The following are attendees by group for the September 16, 2008 meeting, which correspond to the comments given below. The first four groups consist of members of the Purple Line Master Plan Advisory Group. The fifth group (gray background) are interested citizen participants or representatives of groups or offices not specifically represented on the (Planning Board) appointed Purple Line Master Plan Advisory Group.

### East Silver Spring: LRT/BRT High (tunnel)

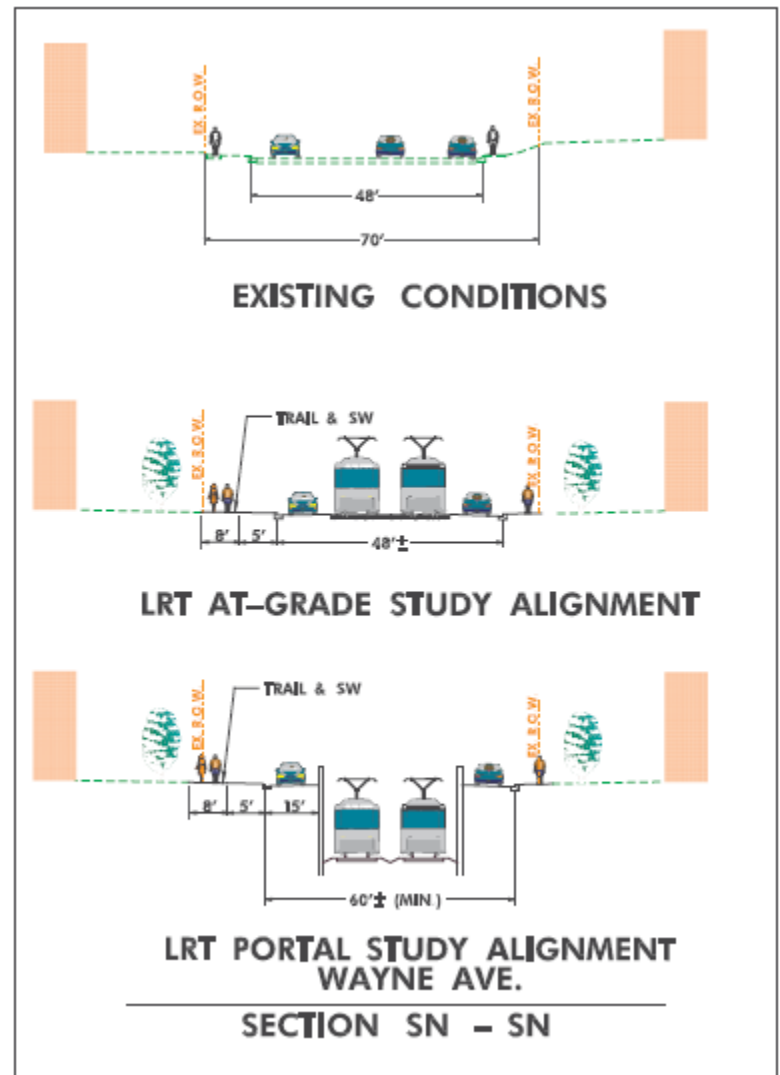
- What is the cross section for Wayne? Do you lose a travel lane?

*Just east of Cedar, there are four lanes or 48 feet of pavement as noted in the drawing.*

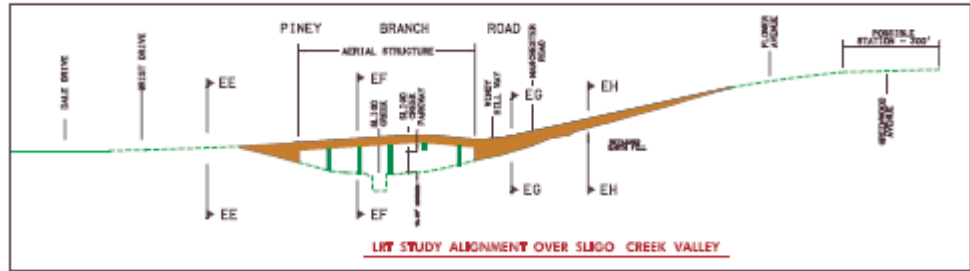
- Wayne is narrower. Where will MTA get the space?
- Where are the stations?

*See insert below:*

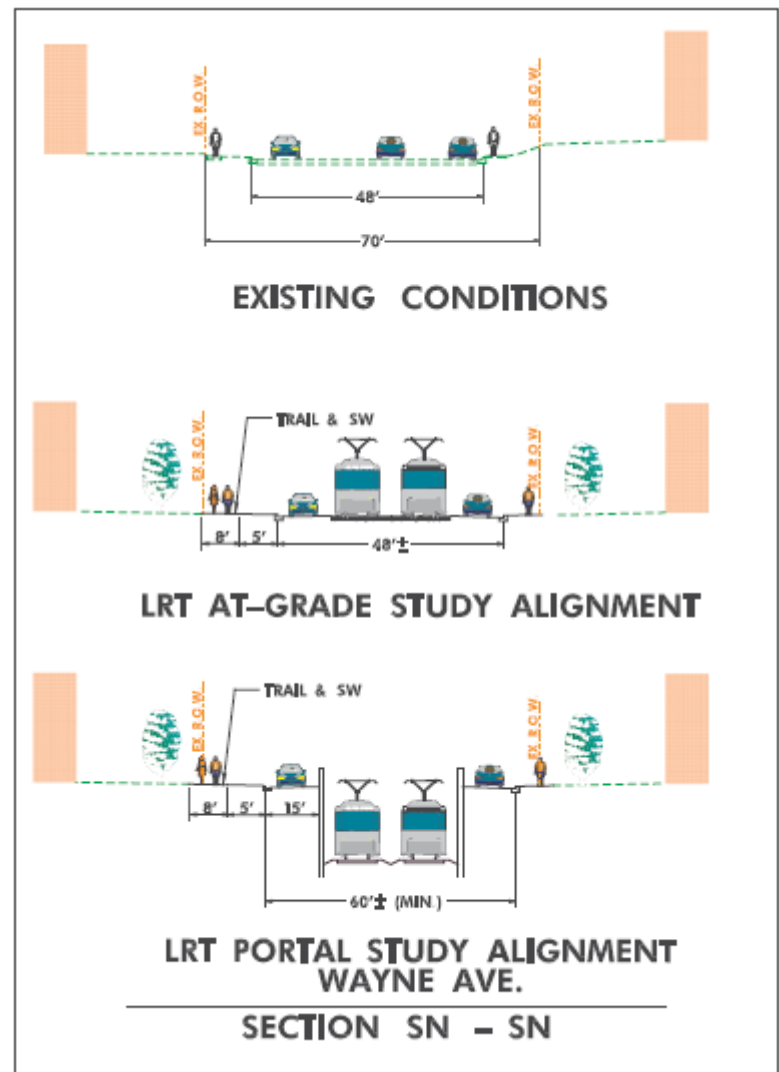
- Was an aerial alternative considered over Sligo Creek to keep it level and above the flood plain? This option would eliminate a travel lane and works with the topography. *There is an aerial option over Sligo Creek for the High Investment alternative as noted to the right.*

- Need information for the stop at the entrance to the tunnel (portal) on Wayne such as widen road and take apartment building and parking lot.  
*See section SN (the drawing to the right). It pears an additional three feet of right of way is required. We will confirm this and any potential impact upon any adjacent building or parking lot.*
- Widening Wayne is the core concern of the neighborhood
- Other than a station at Dale, are we going to widen Wayne anywhere?  
*See response to related question above.*
